Subject: Duke Energy Carolinas, LLC
William States Lee III Nuclear Station – Docket Nos. 52-018 and 52-019
AP1000 Combined License Application for the
William States Lee III Nuclear Station Units 1 and 2
Response to Request for Additional Information (eRAI 6497)
Ltr# WLG2012.06-07

Lee Nuclear Station Response to Request for Additional Information (RAI)

Reference NRC RAI Number(s): 2.5.4-017

Conceptual MSE Wall Fill Material and Design

Figure 1, SCDOT 305.2.5.5 Macadam Base Course Gradation Limits

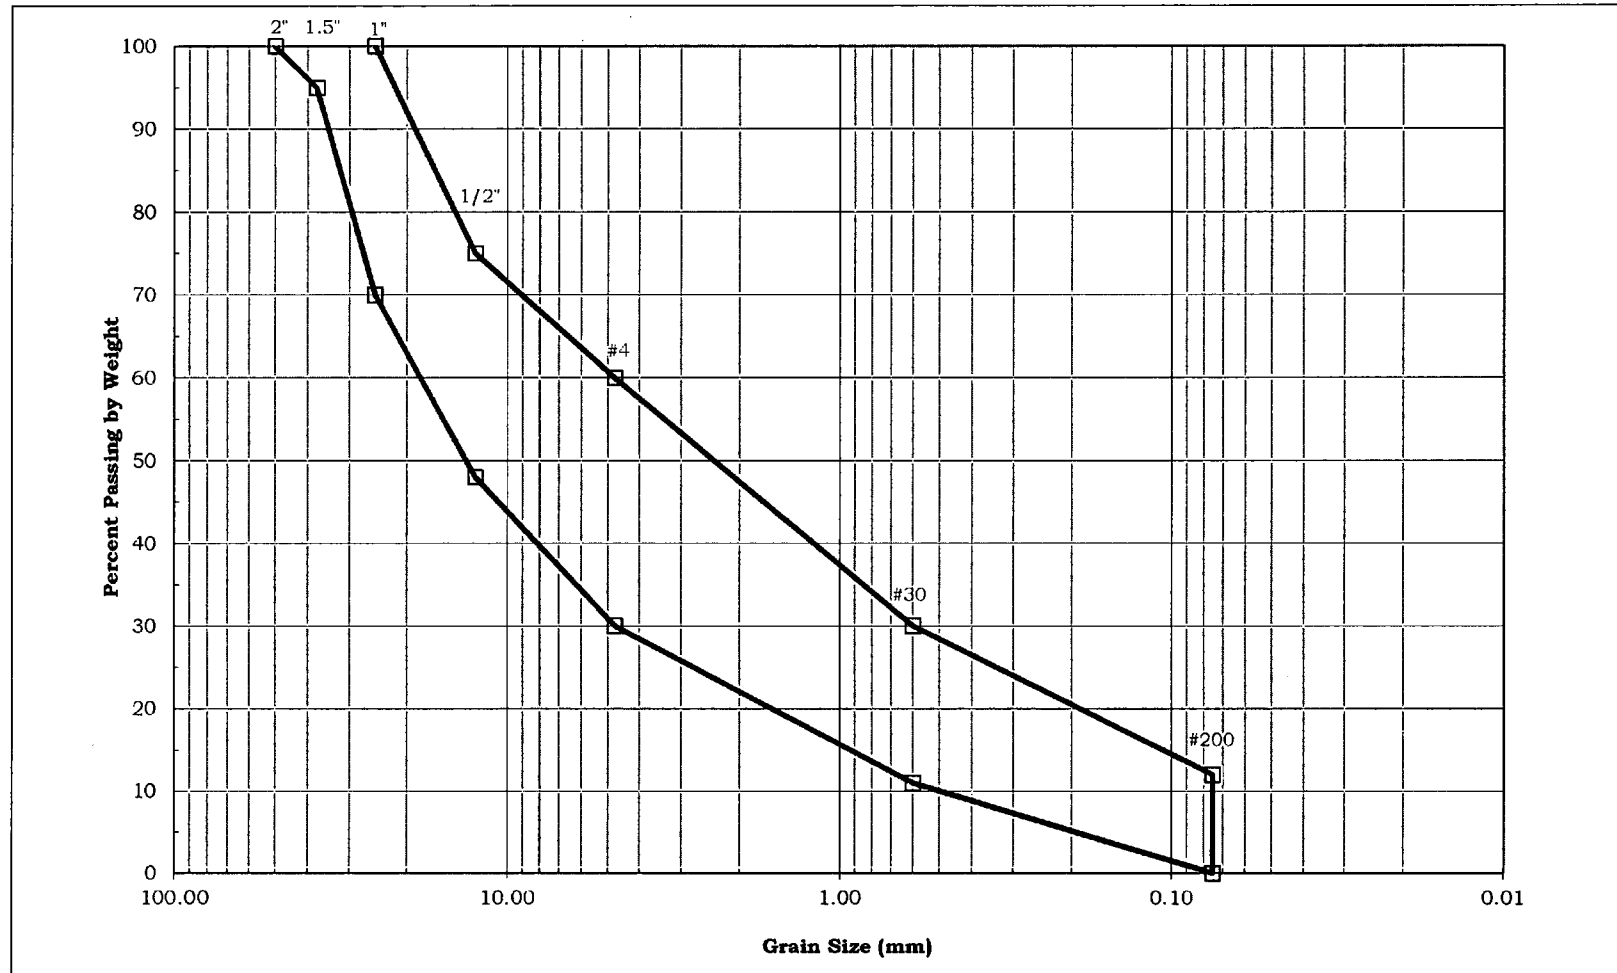
To address these issues and to ensure compliance with 10 CFR 100.23 and 10 CFR Part 50, Appendix S, please: 1) specify the type of soil to be used as backfill material with its classification and static and dynamic properties; 2) discuss how to ensure that as-placed backfill properties are comparable to those assumed in site-specific analyses; 3) provide details of MSE wall design; and 4) discuss its impact on side fill compaction and structural stability analyses so that the staff can conduct a full evaluation of foundations/structures stability.

As stated in FSAR Subsection 2.5.4.5.3.5, Granular Backfill Outside the Nuclear Island, these granular materials will meet the gradation requirements for Macadam Base Course, defined in Subsection 305.2.5.5 of the South Carolina Department of Transportation (SCDOT) Standard Specifications for Highway Construction, and Washed Screenings, defined in Subsection 408.2.2. The Macadam Base Course materials are also expected to meet the plasticity limits specified in Section 305.2.5.5 of the SCDOT specifications. Thus, these granular fill materials will consist of granular soils (gravels and sands) having limited amounts of fines (i.e., no more than 12 percent), a maximum liquid limit of 25, and a maximum plasticity index of 6.

The upper- and lower-bound gradation limits of the Macadam Base Course are shown on Figure 1.

Figure 3, Conceptual Location of Nuclear Island MSE Wall

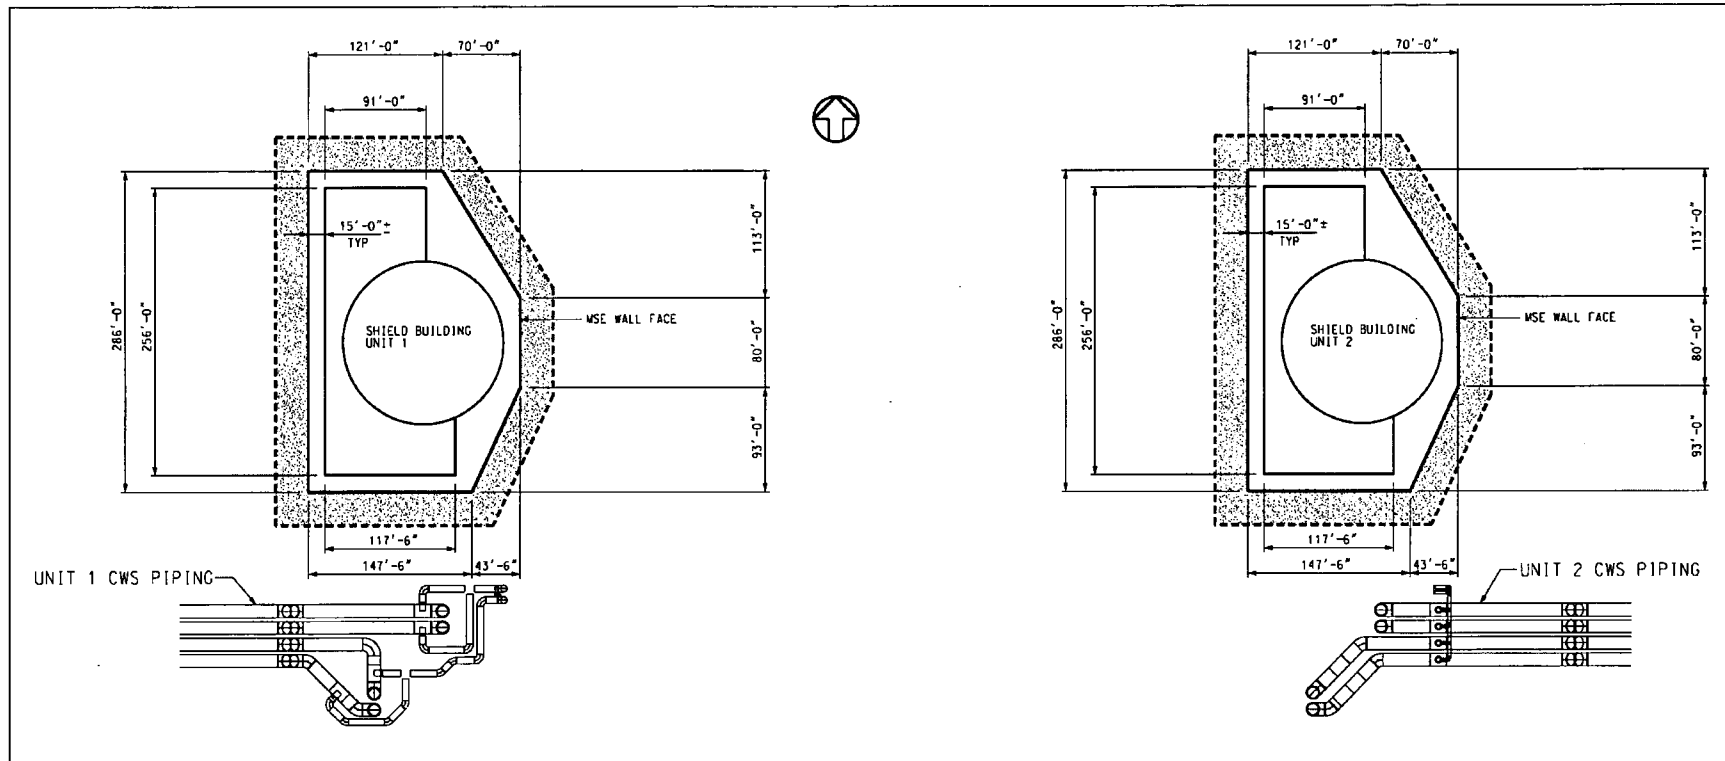
During the audit, the applicant indicated that the GW, GP and SW type of soils, as defined by Unified Soil Classification system, were considered as back fill in its site response and SSI analyses. The applicant also plans to utilize a gabion/MSE wall to support fill adjacent to the nuclear island (NI). However, the staff notes that the FSAR Section 2.5.4 does not specify the soil classification of the backfill soil to be placed around Category I and adjacent Category II structures. Similarly, staff finds that there is no mention of the MSE wall in FSAR Section 2.5.4.

During construction of Lee Nuclear Station Units 1 and 2, a retaining wall will be constructed within each power block excavation to facilitate construction of the nuclear islands. These retaining walls are planned as mechanically stabilized earth (MSE) walls and will remain in place after construction is complete, becoming a permanent part of the subsurface profile. As shown in Figures 3 and 4, each MSE wall is anticipated to be located approximately 15 ft from the nuclear island. At least 6 ft of working space will be provided at the base of the nuclear island. Assuming that the slope of the MSE wall face will be approximately 1 horizontal to 18 vertical, the setback from the nuclear island at the top of the MSE wall (at plant grade Elevation 589.0) will be approximately 17 ft. Note, however, that the top of the MSE wall may be established taking into consideration the subgrade bearing elevation of the adjacent power block structures, which will be slightly below Elevation 589.0. The space between the face of the MSE walls and the below grade portion of the nuclear island walls will be backfilled prior to construction of the power block structures located adjacent to or on top of the MSE walls.
